Meeting:	PLAN COMMISSION OF THE CITY OF WAUSAU
Date/Time:	Tuesday, January 21, 2025, at 5:00 PM
Location:	City Hall (407 Grant Street, Wausau, WI 54403), Council Chambers
Members:	Mayor Doug Diny (C), Eric Lindman, Sarah Watson, Lou Larson, Bruce Bohlken, Andrew Brueggeman, George Bornemann

To: Plan Commission
Prepared By: Andrew Lynch, AICP Asst City Planner
Date: January 14, 2025

Specific Implementation Plan

LOCATION:	700, 804, 806, 810, 814, 816 Grand Avenue
APPLICANT:	M+A Design on behalf of Commonwealth Development
EXISTING ZONING:	PUD - GDP
EXISTING LAND USE:	Vacant
SIZE OF PARCEL:	1.15 acres
REQUESTED ZONING:	PUD - SIP
PURPOSE:	The petitioner will construct an affordable 50-unit apartment building
OTHER PLANS:	Strategic Plan – Thriving Economy. Goal 5: Continue to collaborate with businesses to create a new and improved existing housing stock. Wausau Metropolitan Housing Assessment 2022 – Pursue new construction of housing of all types and prices.

C4

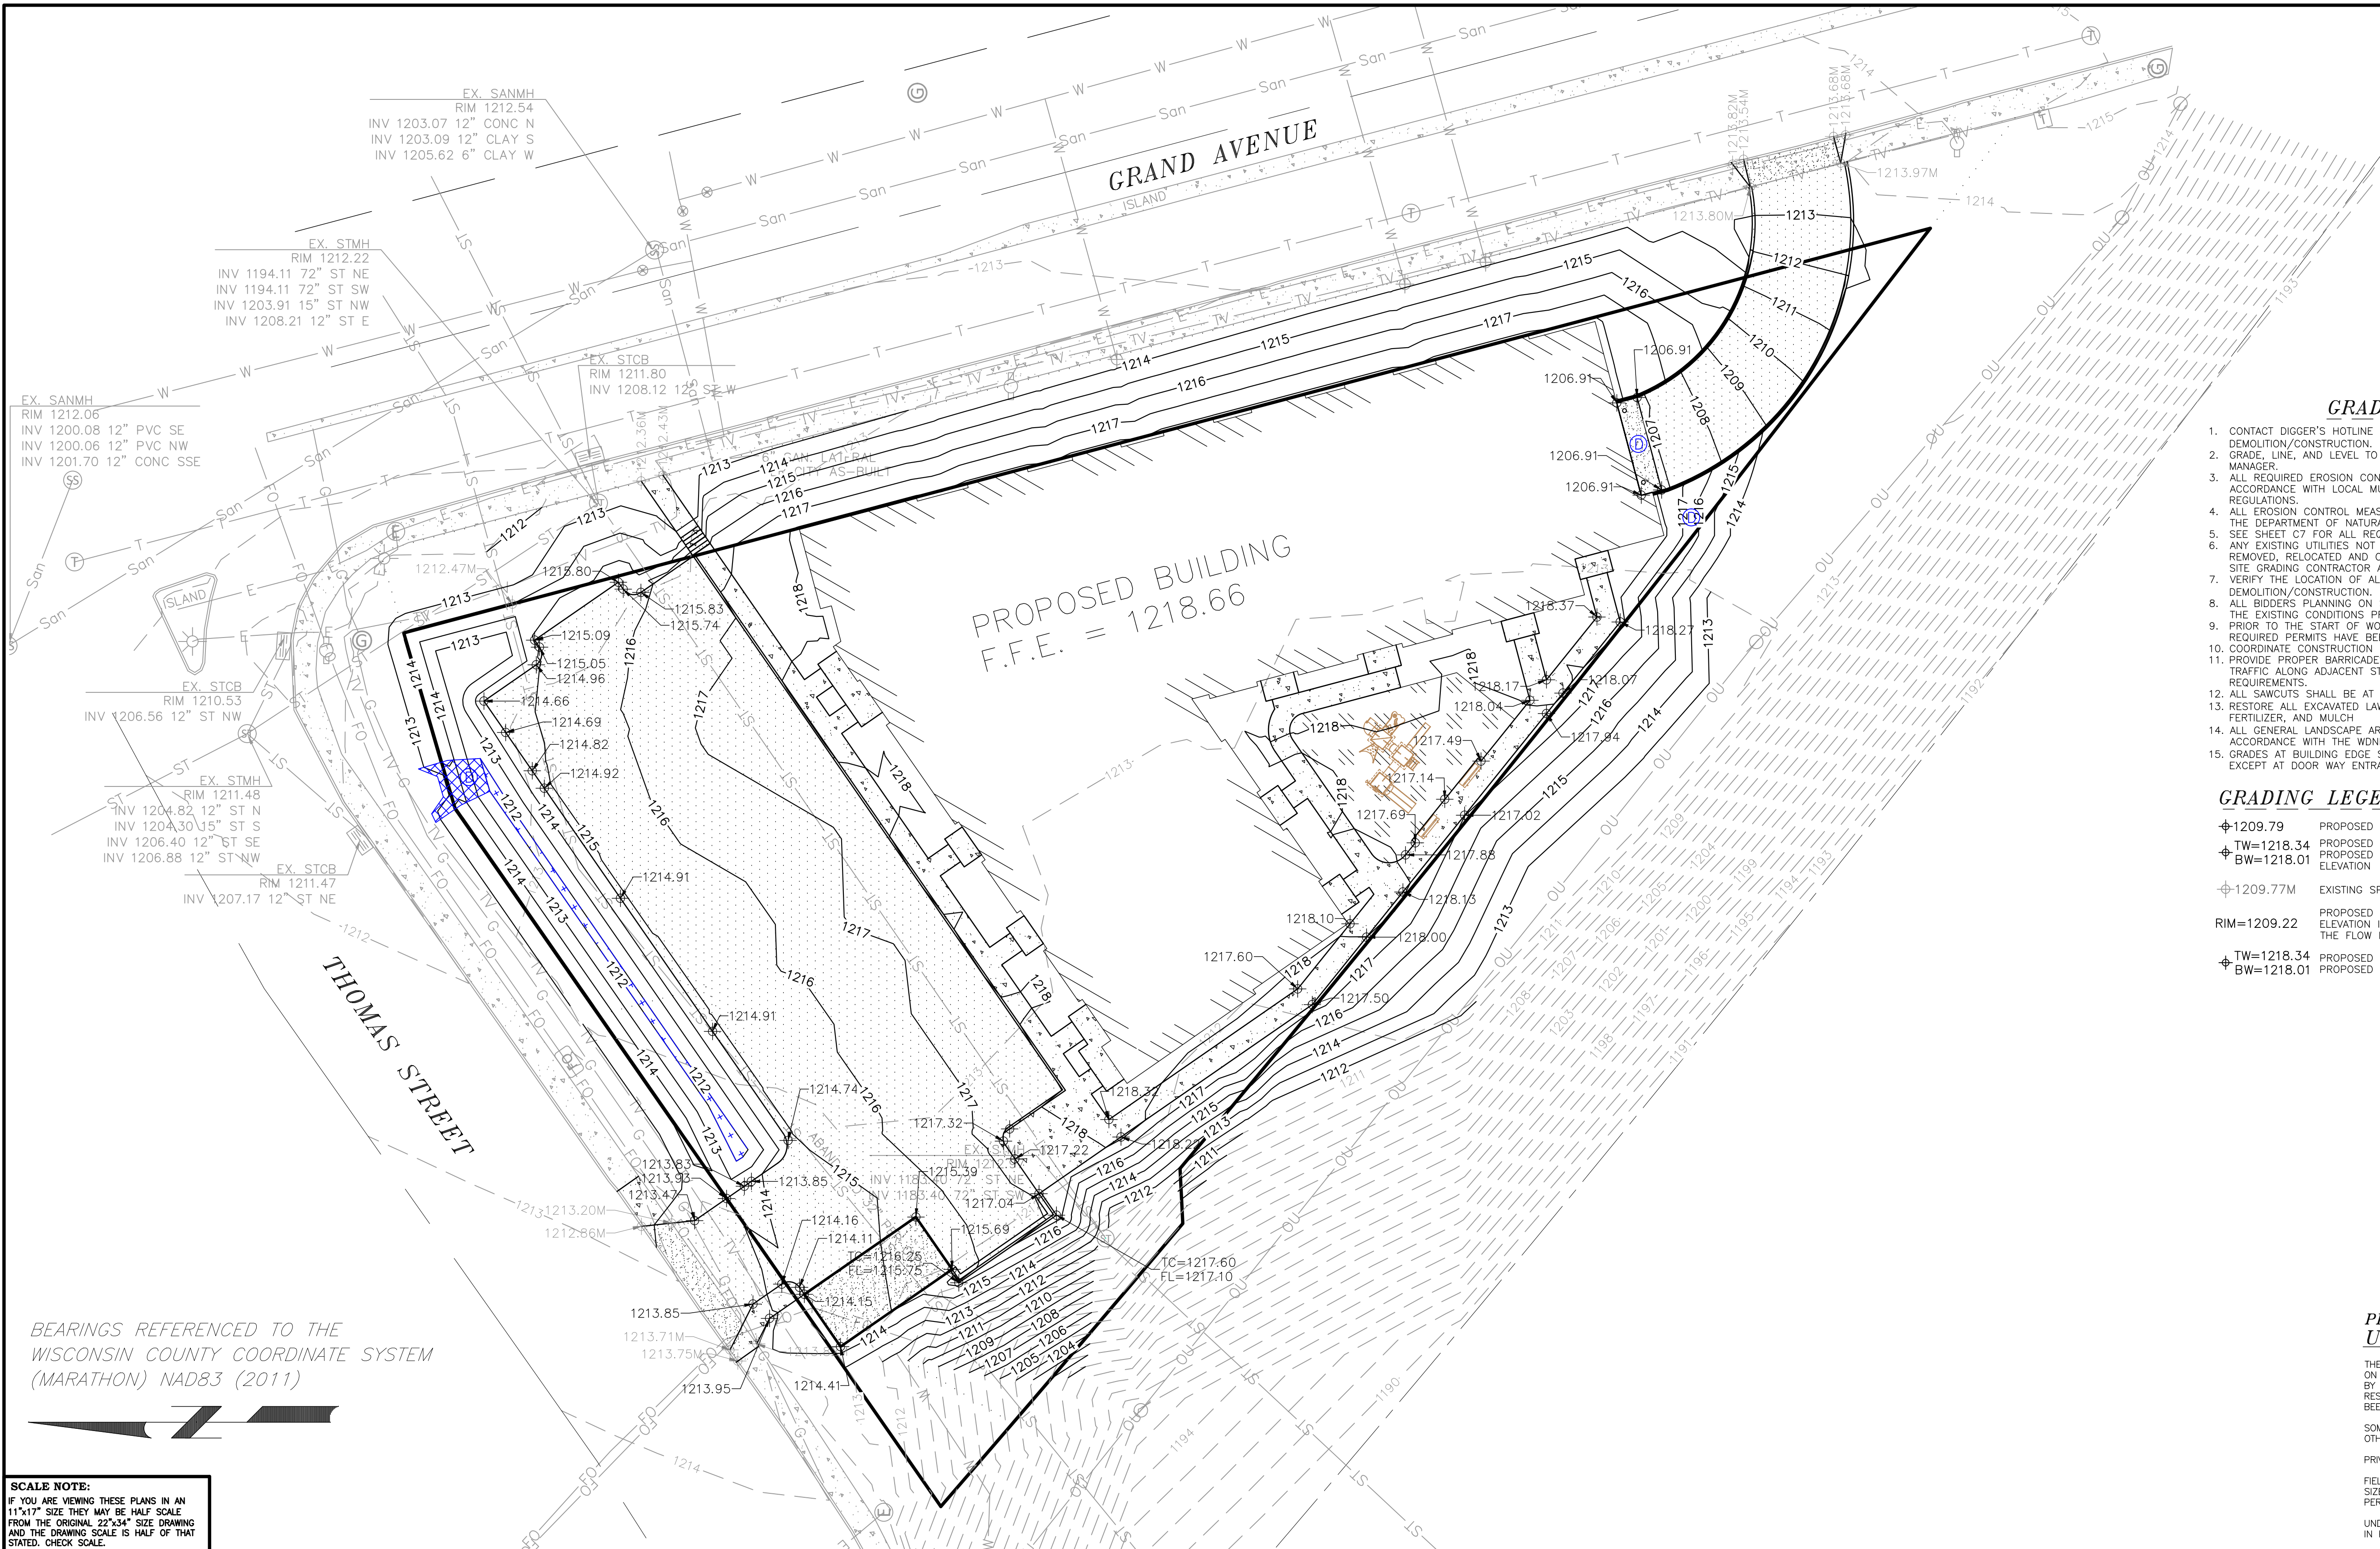
- a. *Yes. The landscaping plan shows adequate screening of the surface parking lot as well as additional trees on the east side of the building. The east side is setback and additional 20' to accommodate future road expansion. Plans do need to show adequate fencing of the trash corral.*
